L-630 New Brentwood Center

ADDENDUM #4

May 7, 2018

Los Medanos College

C1 WALL ASSY - W2 - ISOMETRIC VIEW OF LARGE FORMAT FIBER CEMENT PANELS
1 1/2" = 1'-0"

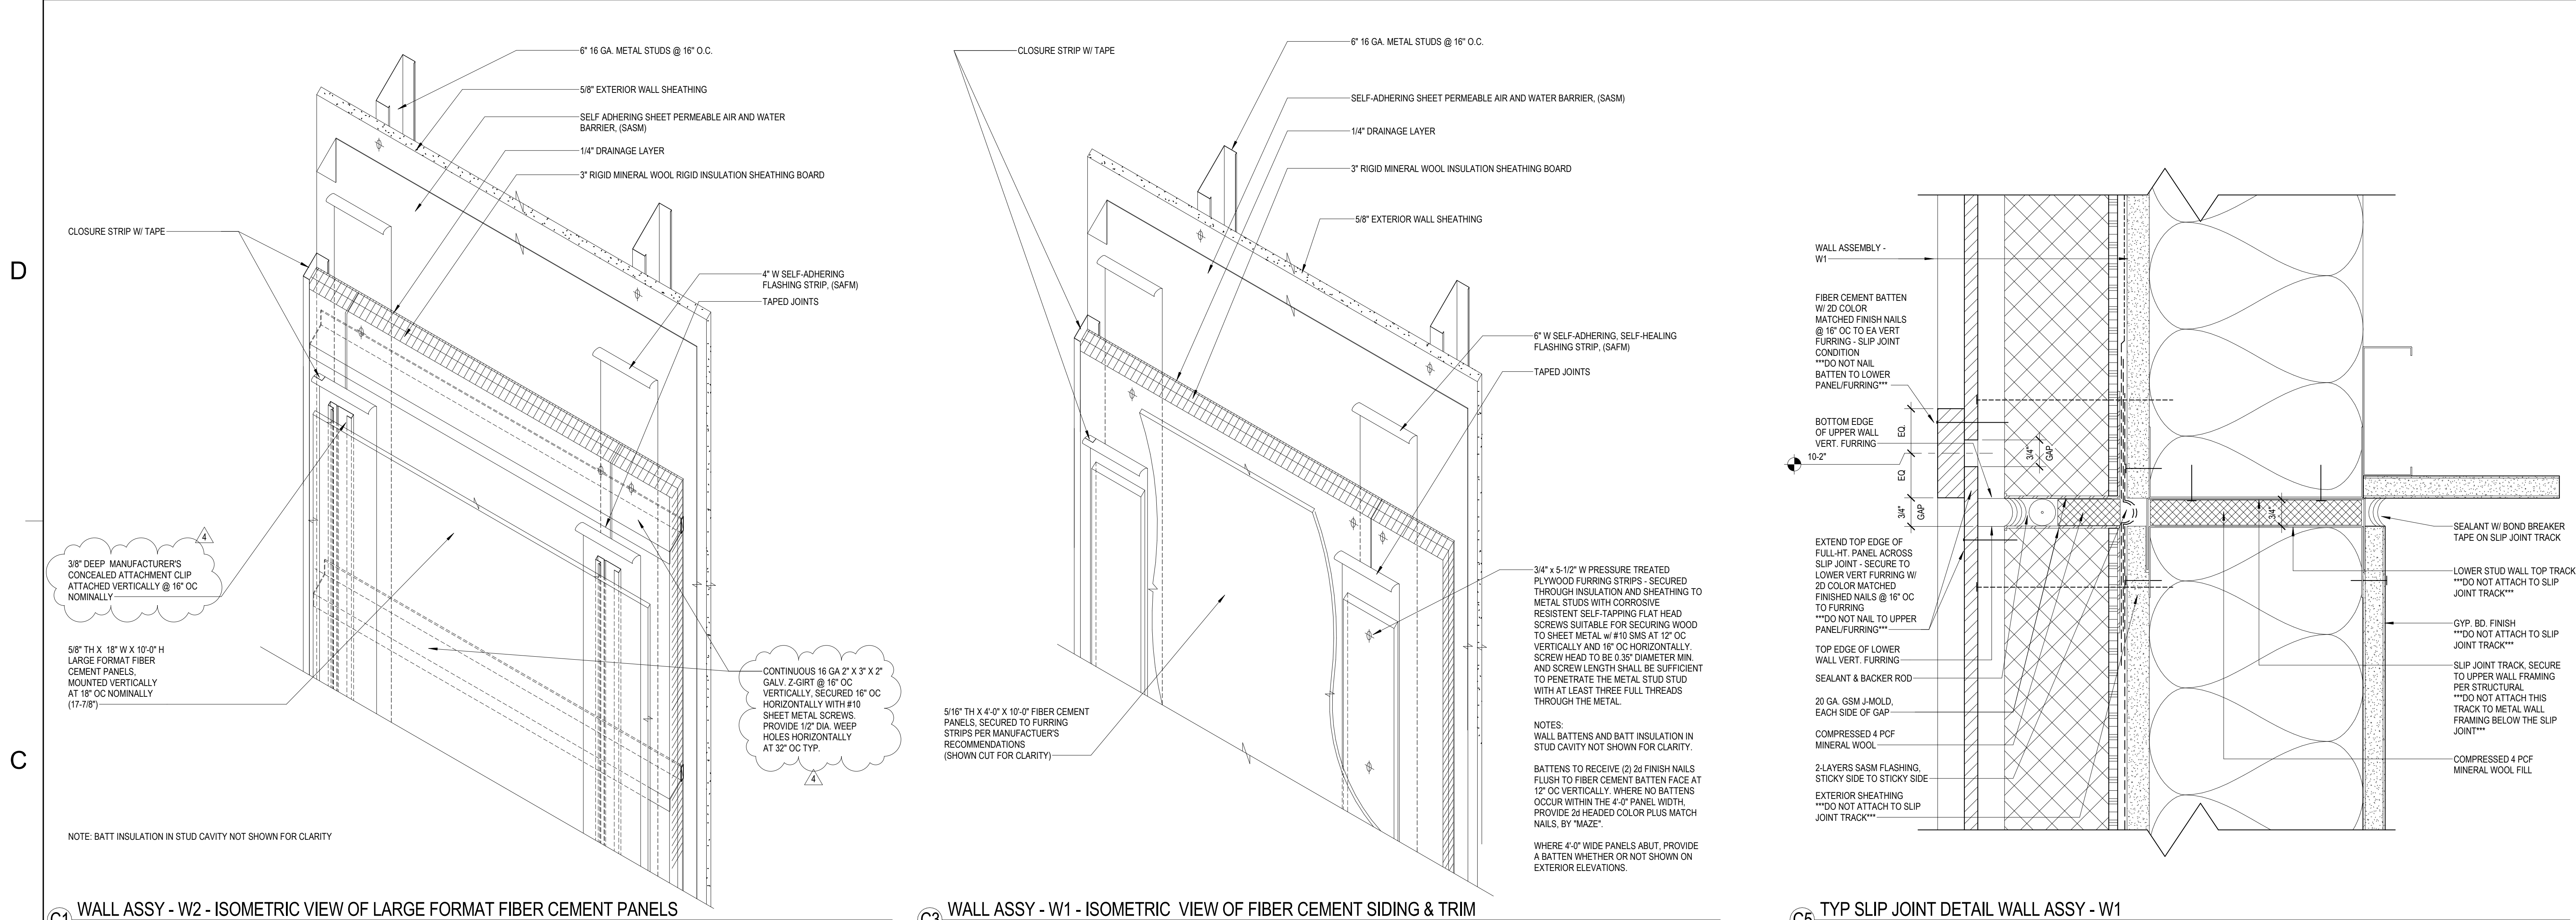
Details A2 and C1: Revised horizontal Z-girt spacing to 16” on-center vertically; revised vertical panel clip attachment screw spacing to 16” on-center.

A2 WALL ASSY - W2 - LARGE FORMAT FIBER CEMENT PANELS (SECTION VIEW)
3" = 1'-0"

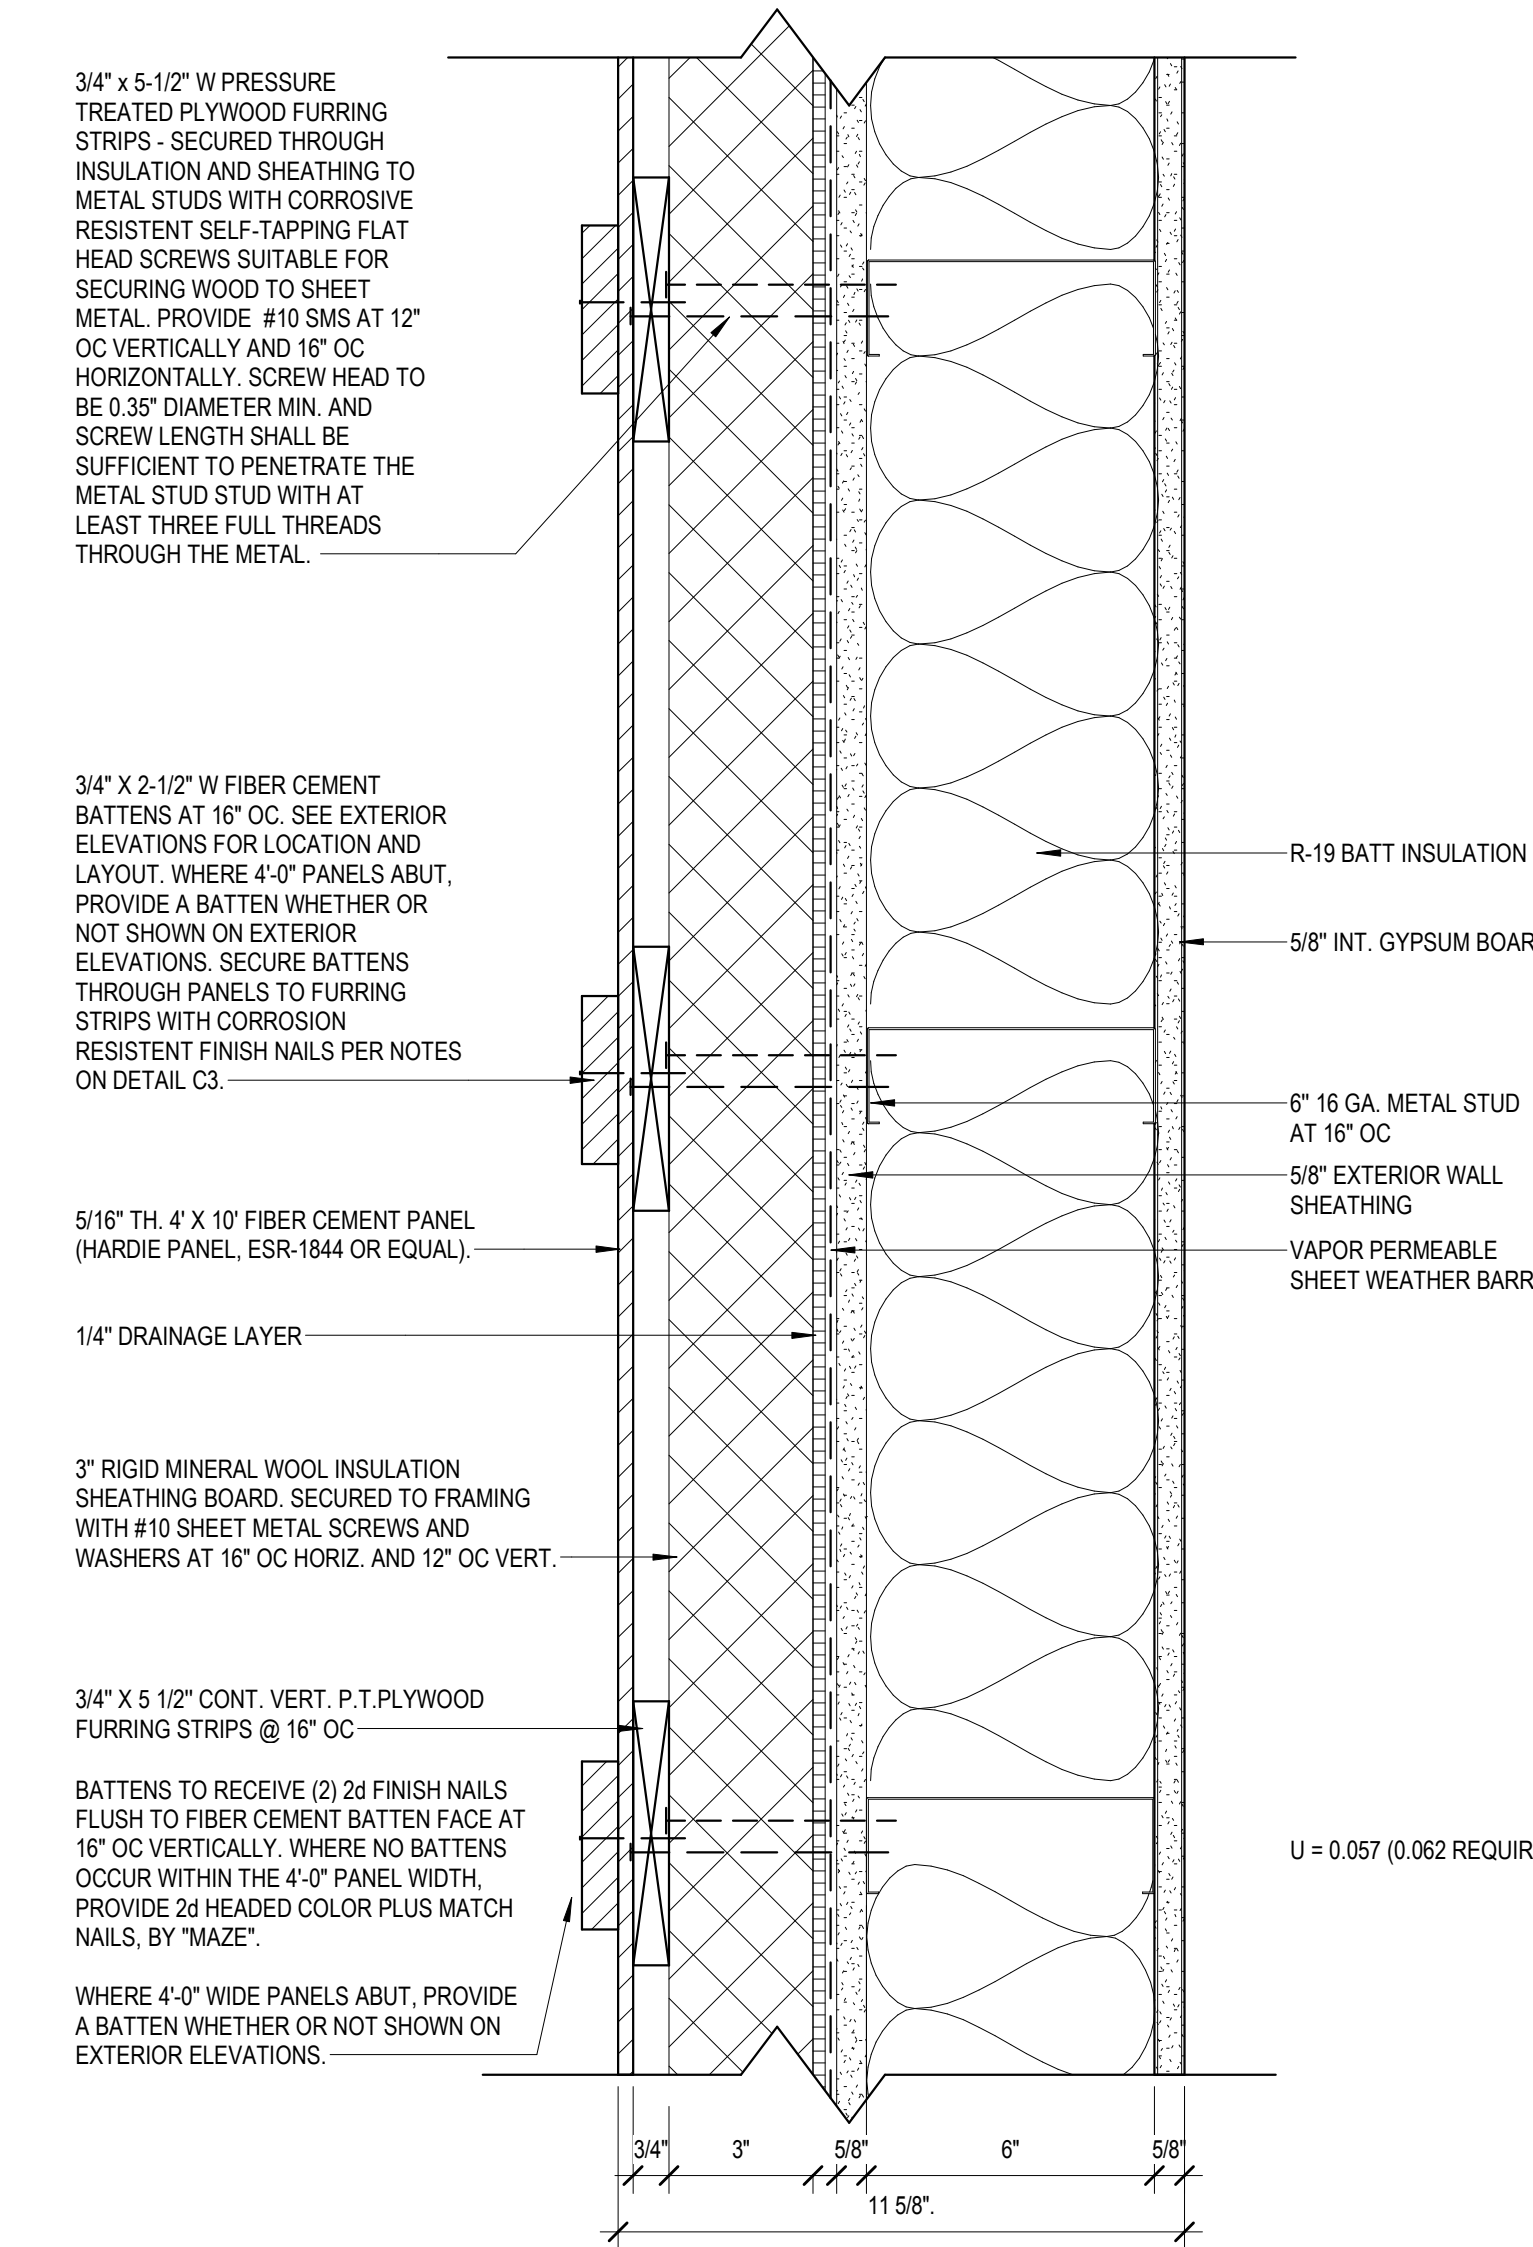
1. **Question: RFI 001: The Nichiha large format fiber cement panels will not align with the framing as currently drawn.**

Response: Nichiha panels are oriented vertically are supported with a continuous starter track and held in place with vertical clips. Clips are attached to horizontal Z-girts which are attached to wall framing as indicated on Drawings. Z-girt spacing changed per revised drawings attached this addendum.

A2 TYP. LARGE FORMAT FIBER CEMENT PANEL SILL DETAILS
3" = 1'-0"

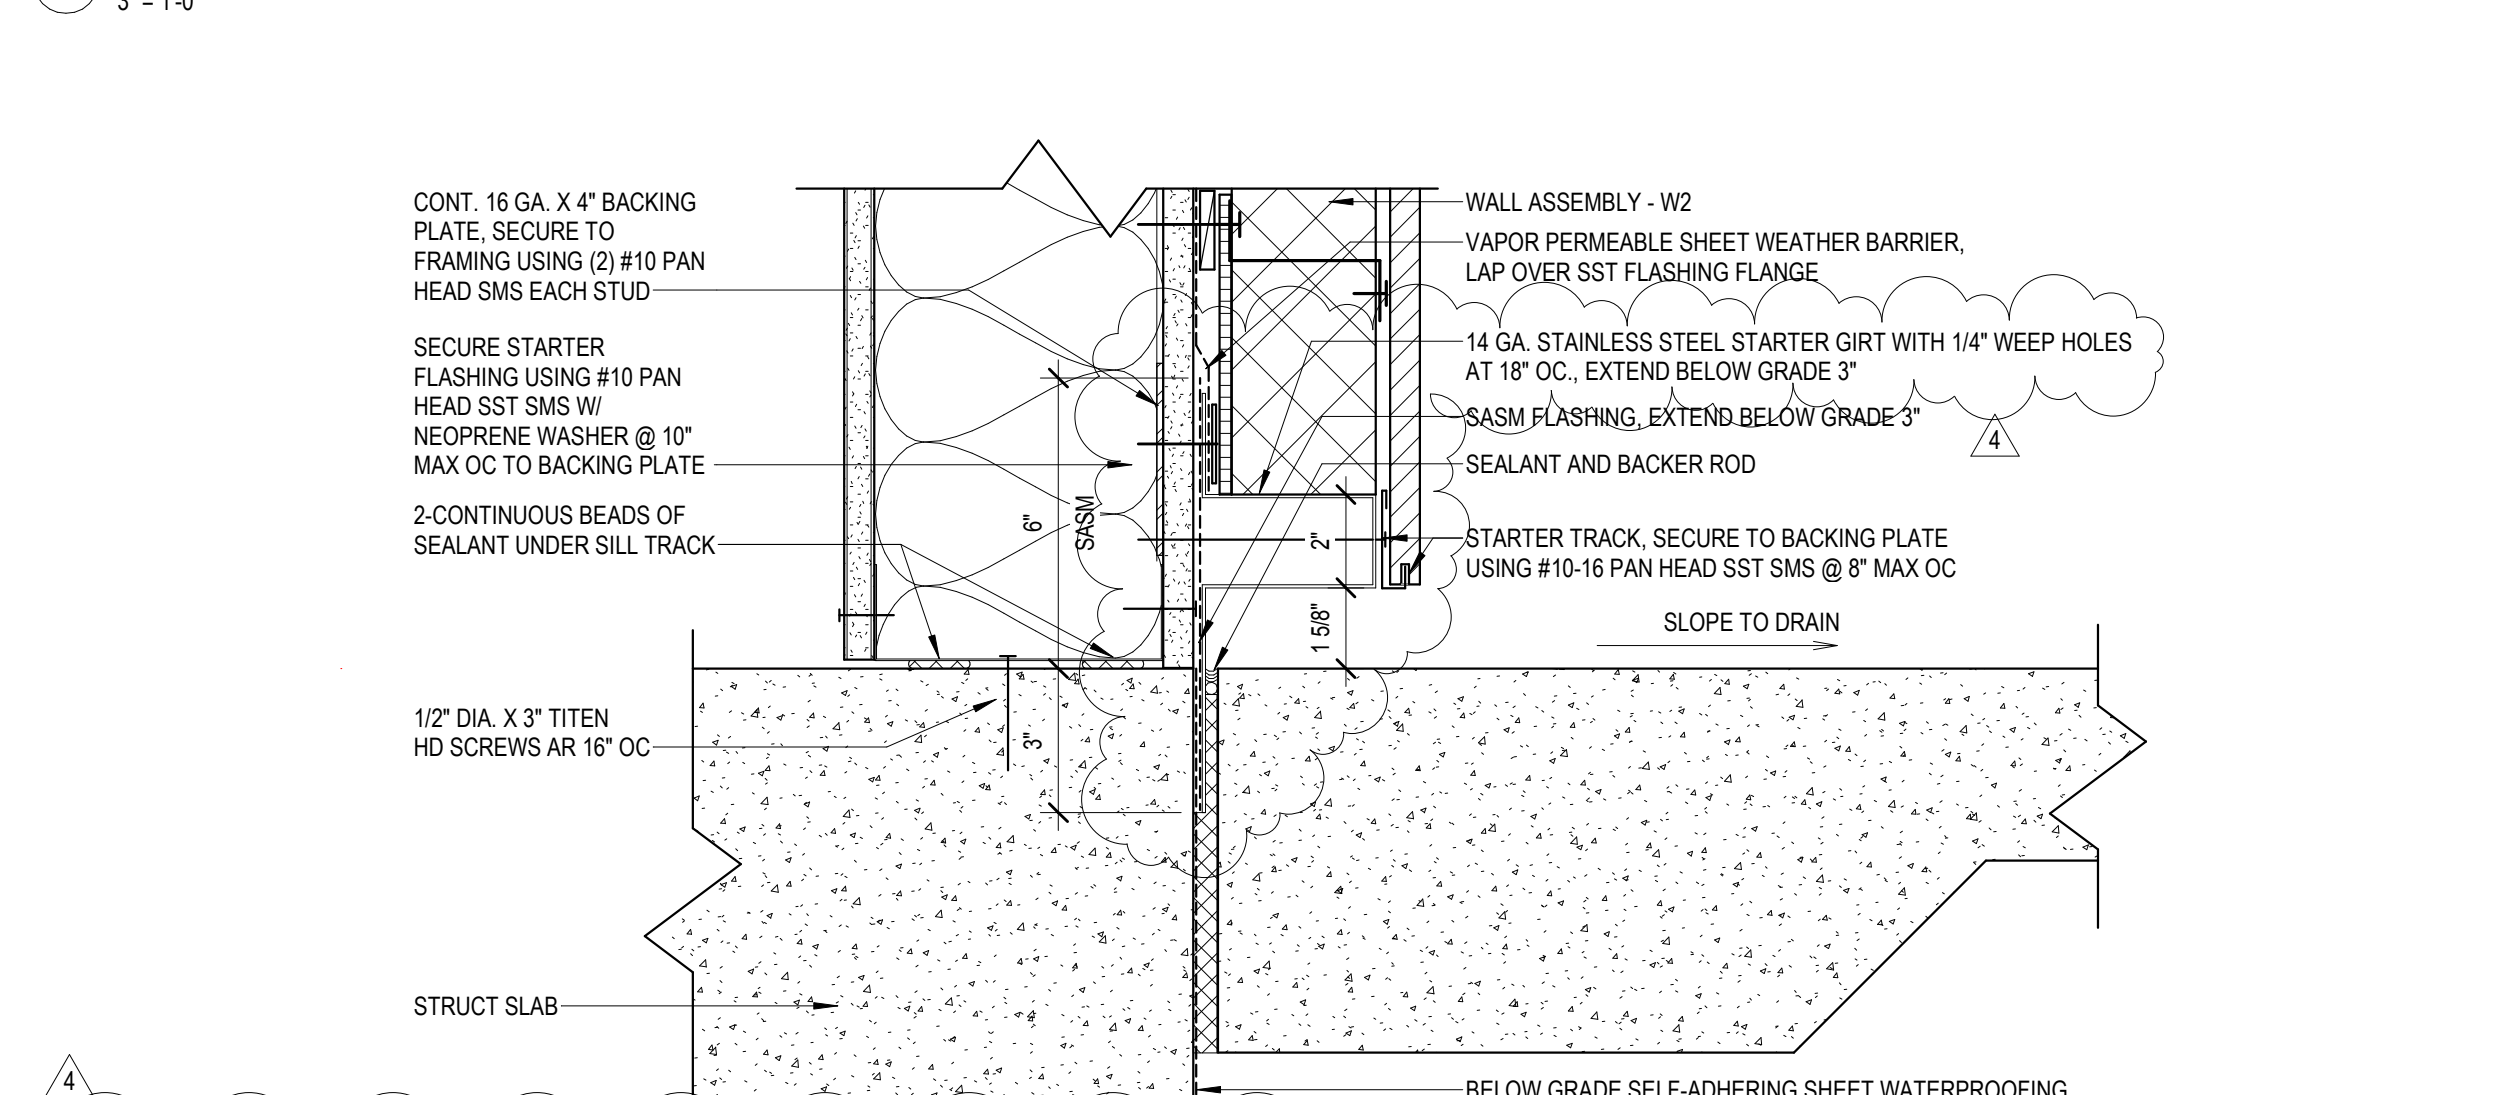
Detail A2: Revised to “TYPICAL LARGE FIBER CEMENT PANEL SILL DETAILS”; revised stainless steel flashing to stainless steel starter girt, including profile; revised metal thickness to 14 gauge.
